Wylfa Newydd Project

Request for Non-Material Change no.3

Worker Shift Patterns

PINS Reference Number: EN010007

Figure 2-1 Location of assessed junctions and their journey time from the Wylfa Newydd Development Area

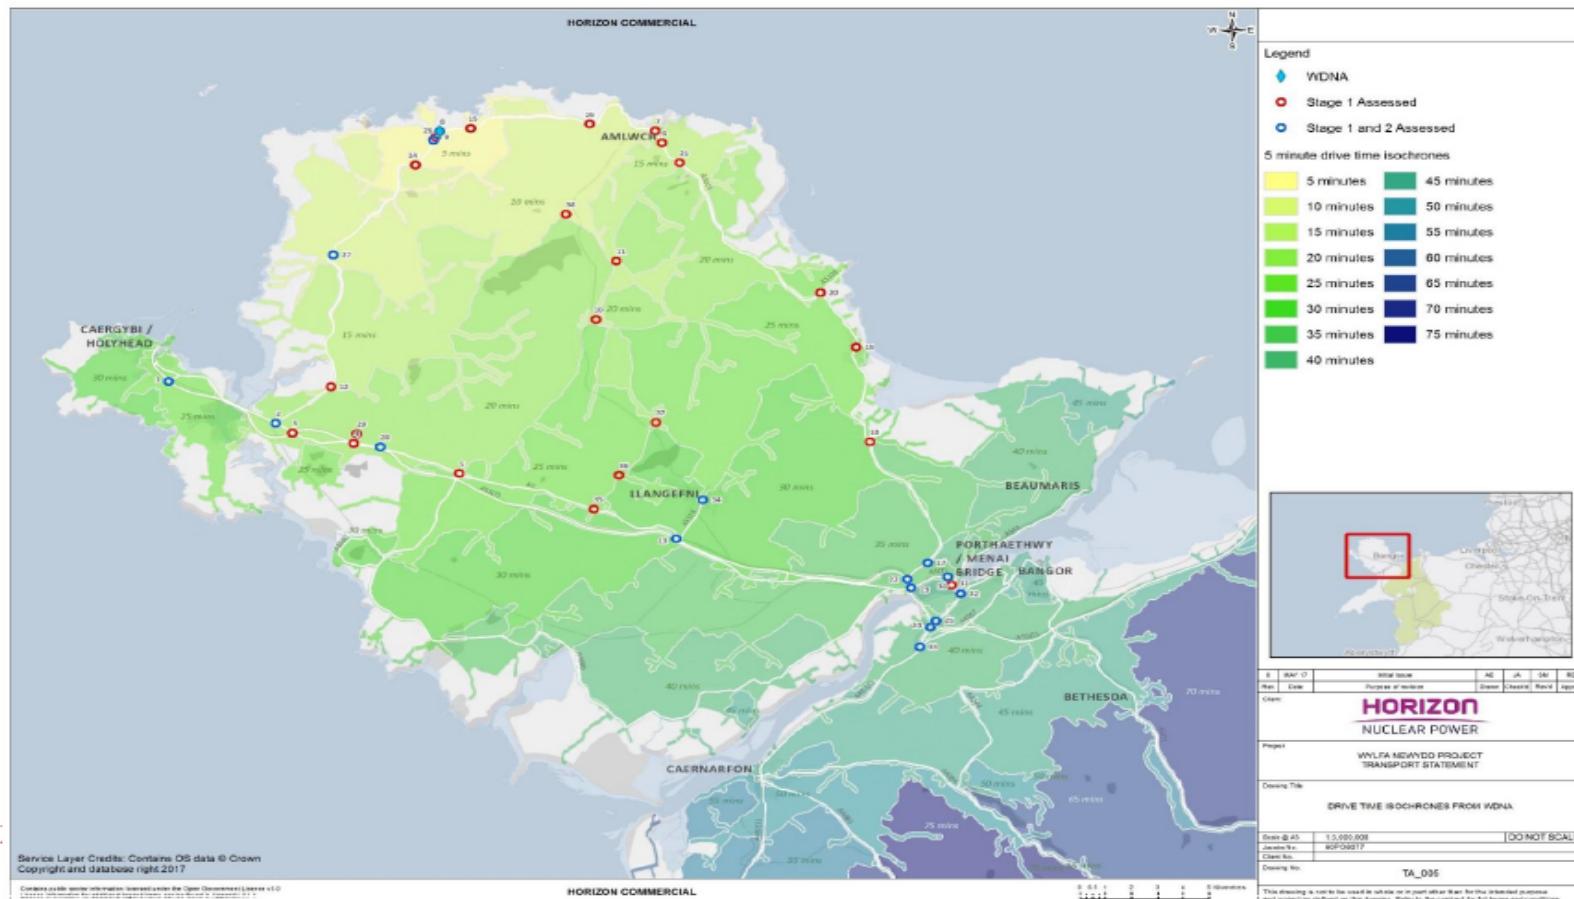
2.3.7 As with the original shift pattern, the proposed change has been designed to ensure that construction shift traffic avoids creating adverse impacts on Britannia Bridge (as identified in Figure 2-1). This is because, under the proposed change:

- 2.5.14 For reference, the locations of the 38 assessed junctions are presented in Figure 2-1. This figure also shows the typical journey time from each junction to the Wylfa Newydd Development Area as this is an important aspect of the assessment.

Figure 3-2 Shift pattern presented in DCO application

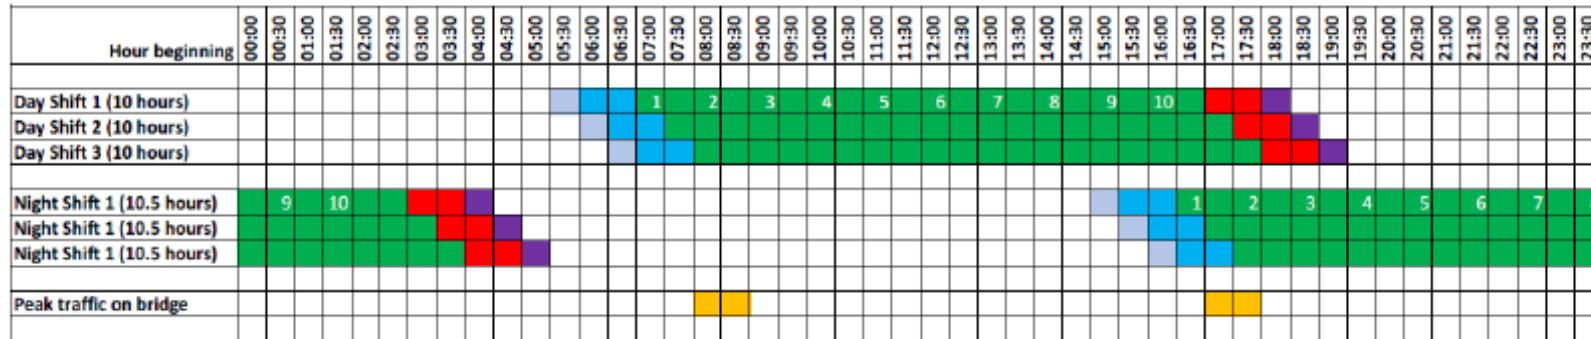
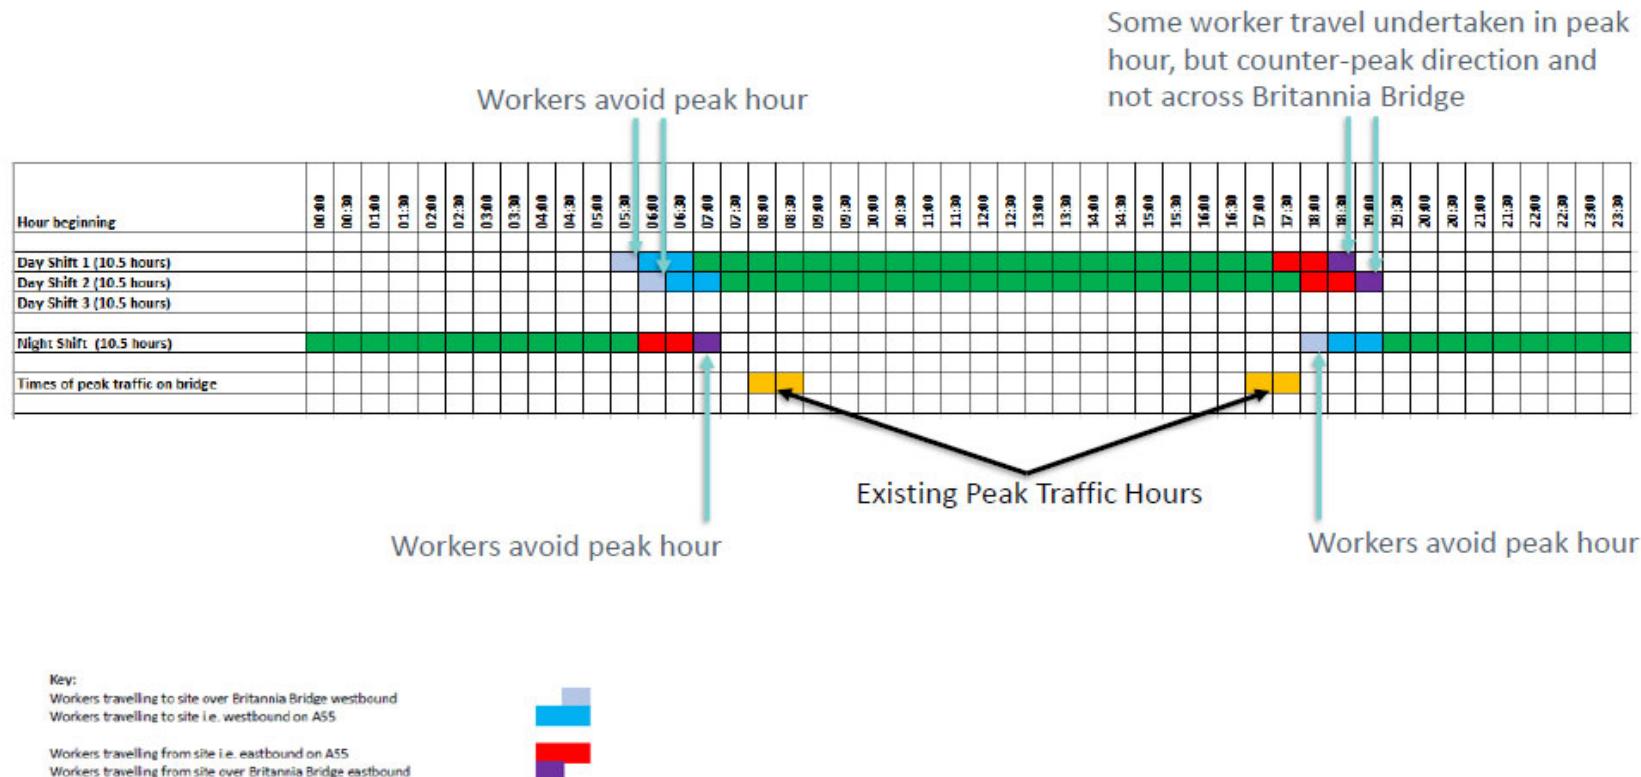
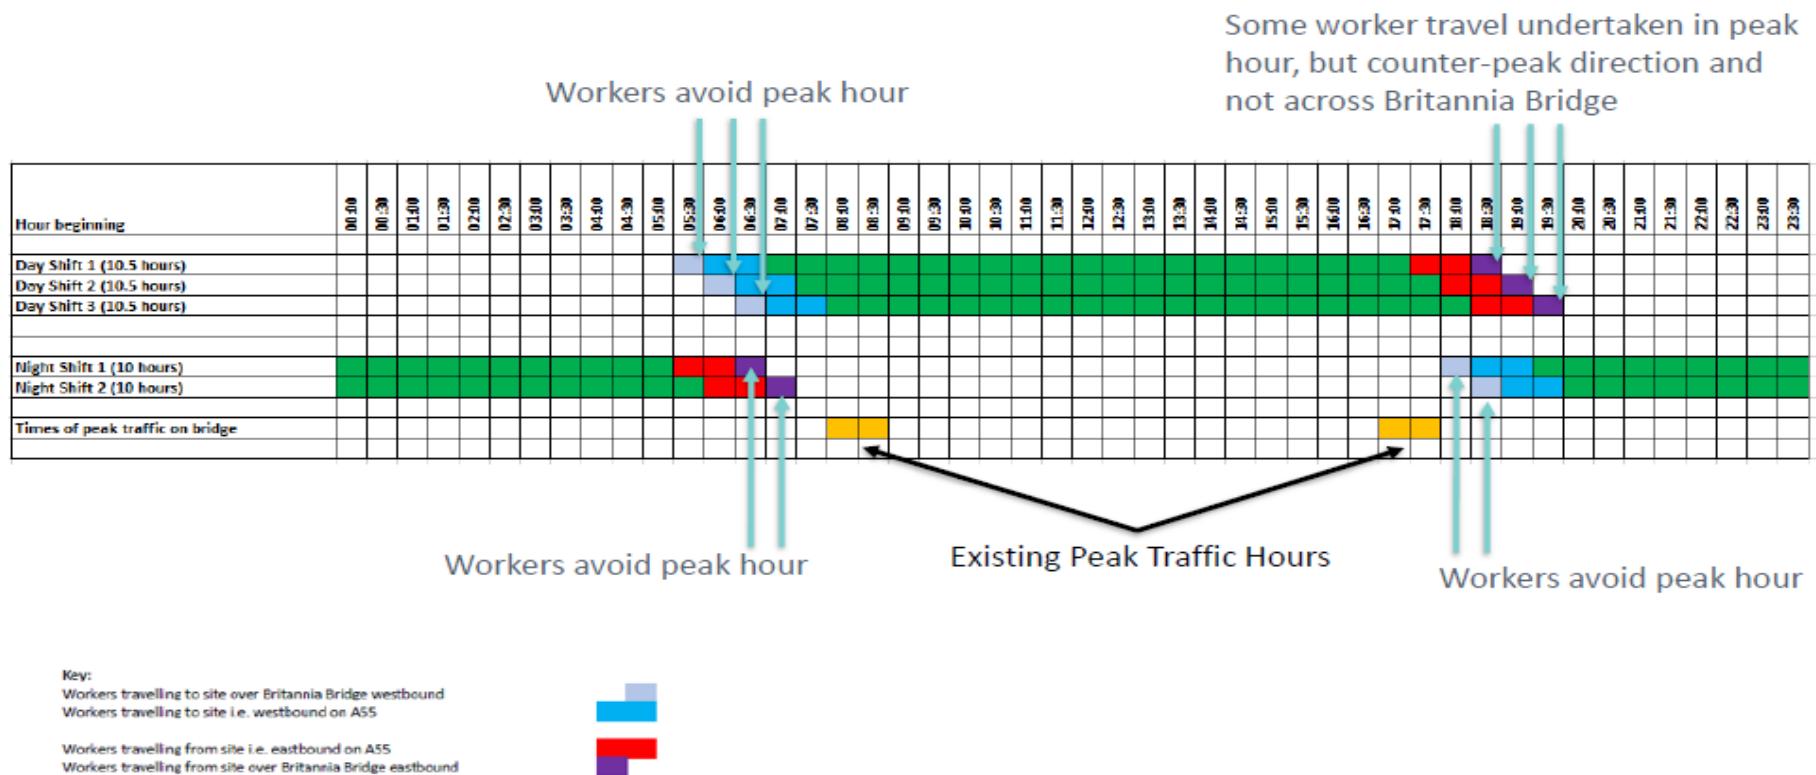
2.2.4 The proposed changes are summarised in Table 2-2 alongside the shift patterns submitted in the DCO application. These are shown visually in appendix 1-2 (see figure 3-2, figure 3-3 and figure 3-4).
